Intel[®] Pentium[®] 4 Processor Specification Update

Release Date: December 2001

Order Number: 249199-016

The following figure will be added as Figure (new). THERMTRIP# Power Down Sequence

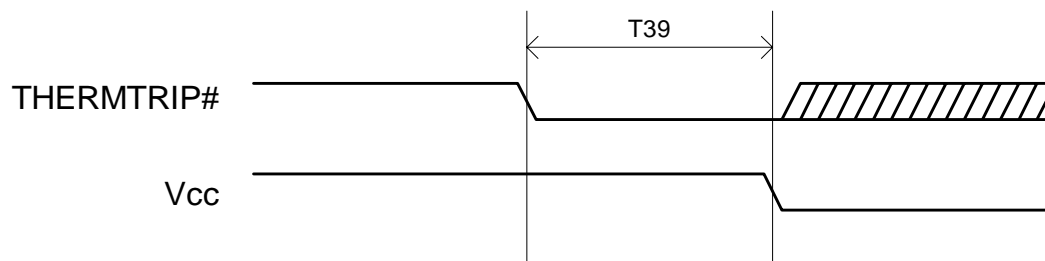
Several parts of the *Intel® Pentium® 4 Processor in the 423-pin Package* datasheet will be updated as follows to clarify the functionality of the Thermtrip# pin.

The description of THERMTRIP# in Table 32, page 69 will now state:

Assertion of THERMTRIP# (Thermal Trip) indicates the processor junction temperature has reached a level beyond which permanent silicon damage may occur. Measurement of the temperature is accomplished through an internal thermal sensor which is configured to trip at approximately 135°C. Upon assertion of THERMTRIP#, the processor will shut off its internal clocks (thus halting program execution) in an attempt to reduce the processor junction temperature. To protect the processor, its core voltage (V_{CC}) must be removed following the assertion of THERMTRIP#. See Figure (new) and Table 13 for the appropriate power down sequence and timing requirements. Once activated, THERMTRIP# remains latched until RESET# is asserted. While the assertion of the RESET# signal will de-assert THERMTRIP# , if the processor's junction temperature remains at or above the trip level, THERMTRIP# will again be asserted after RESET# is de-asserted.

The following specification will be added to Table 13, page 24.

<u>T# Parameter</u>	<u>Min</u>	<u>Max</u>	<u>Unit</u>	<u>Figure</u>	<u>Notes</u>
T39: THERMTRIP# to removal of power	N/A	500	ms	(new)
